Wisconsin Department of Transportation

Proposal #04: 5990-00-32, WISC 2017 003
City of Janesville, Sharon Road
Spring Brook Creek Bridge B-53-0374
Local Street
Rock County

This is Addendum No. 01, which provides for the following:

ADDENDUM NO. 1

Addendum No. 01
ID 5990-00-32
Revised Sheet 26
January 3, 2016

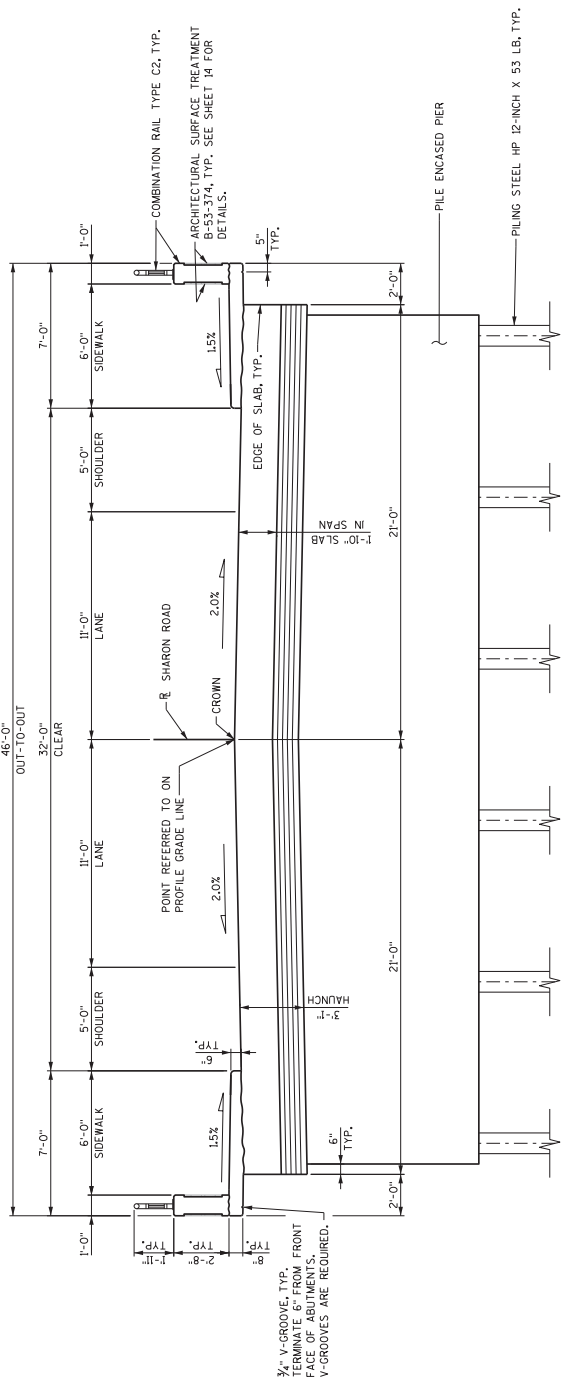
Revised Plan Sheets	
Plan Sheet	Plan Sheet Title (brief description of changes to sheet)
72	Structure B-53-374; Cross Section, Quantities, and General Notes (Piling quantities have been updated at both abutments in the Estimate Quantities table)
26	Miscellaneous Quantity Section Invert elevations were revised to match the storm sewer drawings

CAT. 0010	STRUCTURE	STATION	OFFSET*	MANHOLES 6-FT DIAMETER	INLETS 4-FT DIAMETER	CONCRETE INLETS 2X3-FT	ELEVATION	#	INVERT ELEVATION	DEPTH**
	IN-1	100+40	15.0' RT	--	1	--	775.14	1	770.76	3.38
	IN-2	100+40	15.5' LT	--	--	1	775.08	1	770.91	3.17
	MH-3	100+65	26.5' RT	--	1	--	774.88	1	770.67	2.96
	MH-4	100+25.5	32.7' LT	1	--	--	774.80	1	771.02	2.78

608.0412	STORM SEWER PIPE REINFORCED CONCRETE CLASS IV 12-INCH	INLET	DISCHARGE	SLOPE	
		LF	ELEVATION	FT/FT	
	MH-4 - IN-2	22	771.02	770.91	0.005
	IN-2 - IN-1	30	770.91	770.76	0.005
	IN-1 - MH-3	18	770.76	770.67	0.005
	MH-3 - AP-4	26	770.67	770.54	0.005
		96
